PROTECT COASTAL SUSSEX

Written Representation for the Rampion 2 Windfarm Examination
(Project Reference: EN010117)

A Community-led Local Impact Assessment (LIA)

PCS: IP Registration Number: 20044835
Submission Date: Final due 28 Feb 2024

Figure 5-1: Comparison of Loads Duration Curves (capacity factor versus % of time) for Rampion 1 on the South Coast (light blue line) versus Hornsea One in the North Sea (green line) and, the average for all UK Offshore windfarms (thicker blue line).

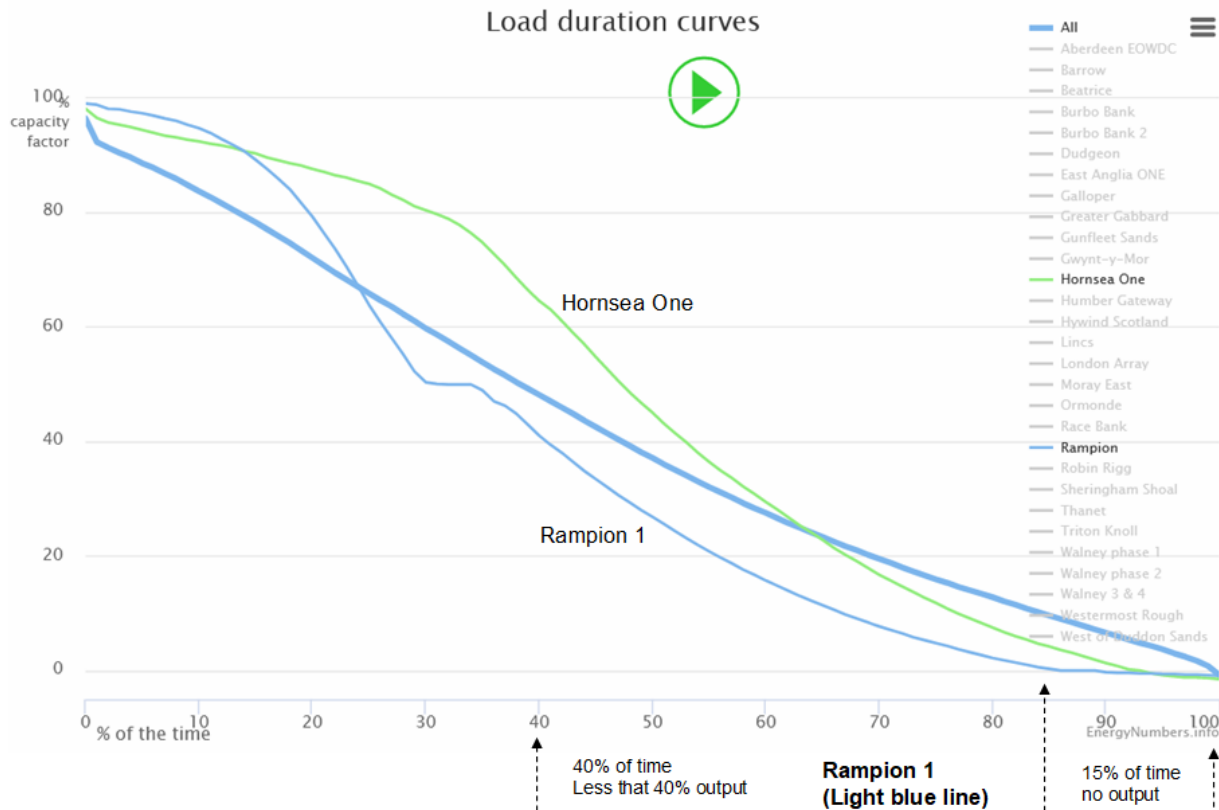
So, Is Rampion 2 less energy efficient and less value for money?

5.46 An illustration of the relative performance of Rampion 2 compared to moving the same turbines offshore to the North Sea is seen in the data in Figure 5-1 below.

Figure 8.20 Predicted worst-case behavioural response impact ranges of herring from the sequential piling of monopile foundations

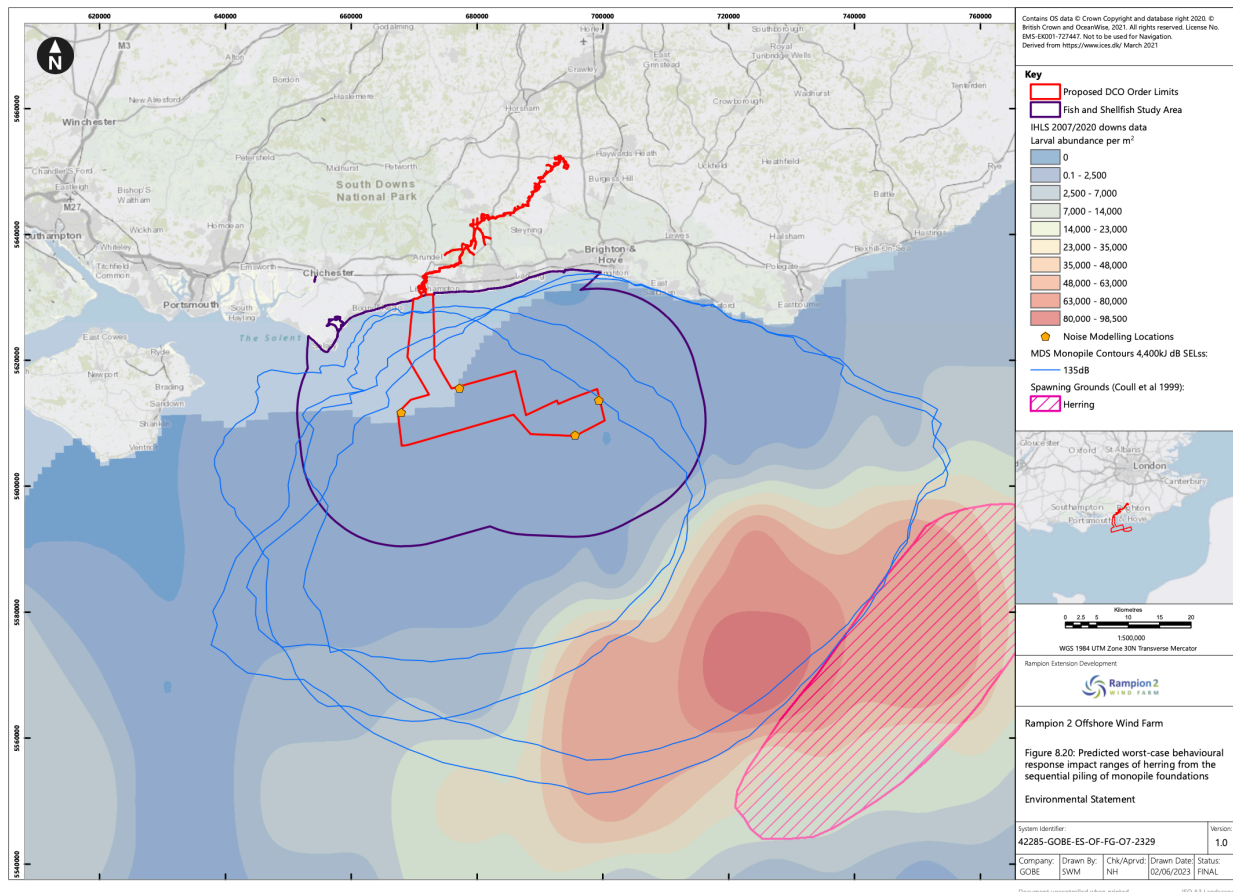
4.6.36 “The MMO disagrees with the Applicant’s assessment of potential impacts to herring from UWN. The MMO notes from the Underwater Noise Impact Assessment that the Applicant has calculated that the range of effect of behavioural responses in herring, based on the recommended modelled threshold of 135dB (Hawkins et al., 2014) may occur as far as 67km from the source of piling.

[The modelling evidences high sound pressure levels travelling across dozens of miles with little attenuation. This is likely to cause severe disturbance.]

Figure 8.19 Predicted worst case impact ranges for stationary receptors from the sequential piling of monopile foundations ⁹

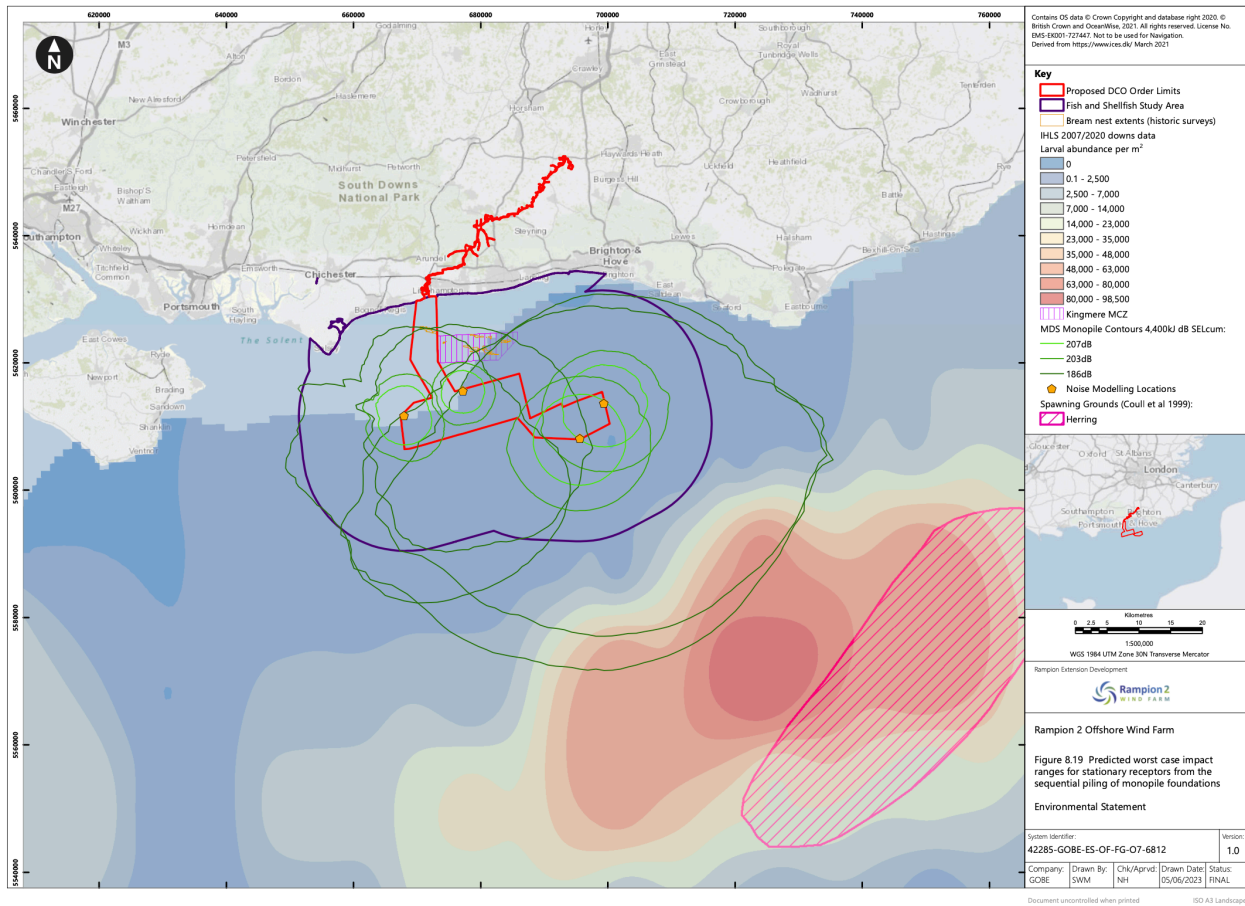
4.6.34 *“The Applicant has acknowledged that the installation of foundations within the Rampion 2 Array Area has the potential to lead to significant injury and/or disturbance to fish species due to underwater noise generated during pile driving. UWN modelling is based on worst-case scenarios of a 13.5m diameter monopile installed with a maximum hammer energy of 4,400kJ, and for a 4.5m diameter pin pile installed with maximum hammer energy of up to 2,500kJ. Tables 8.20 and 8.21 outline the likely impact ranges for mono- and pin-piling at the south location, carried out as a single piling scenario and sequential piling scenario. Likely impact ranges for mortality and potential mortal injury (207 Sound Exposure Level, cumulative (SELcum)), recoverable injury (203 SELcum), and temporary threshold shift (TTS) (186 SELcum) for stationary fish receptor, as per the pile driving threshold guidelines described by Popper et al. (2014) have been presented.”*

The Sound Exposure levels cumulative or otherwise, are likely to be much higher than these.
